Docket Item #3 BAR #2018-00275

BAR Meeting December 19, 2018

**ISSUE:** Alterations

**LOCATION:** 205 The Strand (205 Strand Street)

WEST ELEVATION

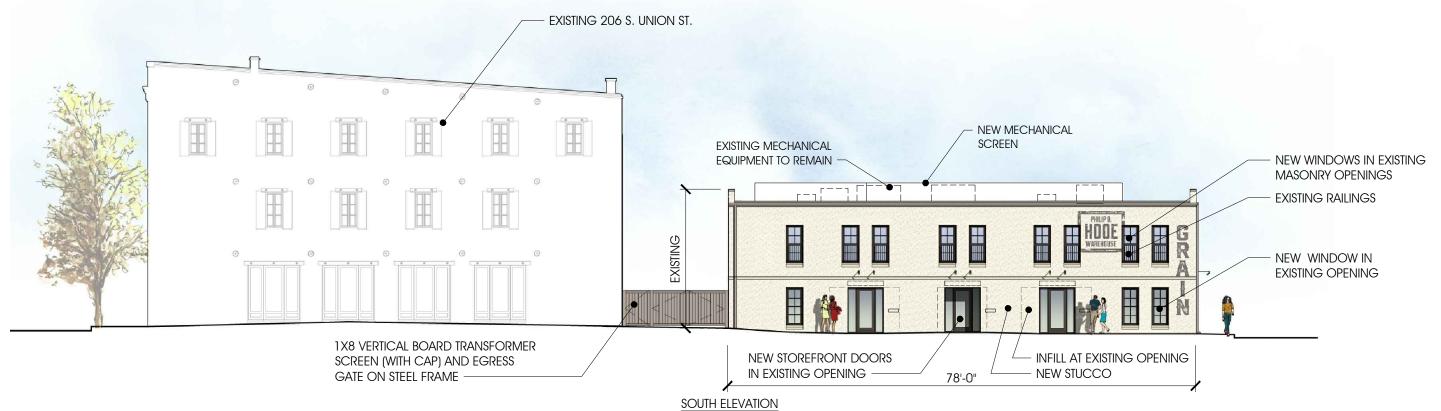
- 1. Wherever possible (i.e., where historic stones remain and where the layer of EIFS can be reasonably removed), incorporate a design that retains the historic stones adjacent to the new stucco. On the west elevation, where there is a stone foundation at the first story, retain the stone and extant arches and strike a line with parged stucco at the second story (approximately 6' above the ground) and also at the western edge of the south elevation.

Based on the site investigation, staff does not object to new lime stucco or parging on the south elevation and above the stone foundation on the west elevation, finding that it may be the best solution due to the damage caused by the removal of the existing EIFS. This approach is consistent with the Design Guidelines which seek to first and foremost preserve historic fabric where it remains intact to the greatest extent possible and to incorporate historic material into any alterations.
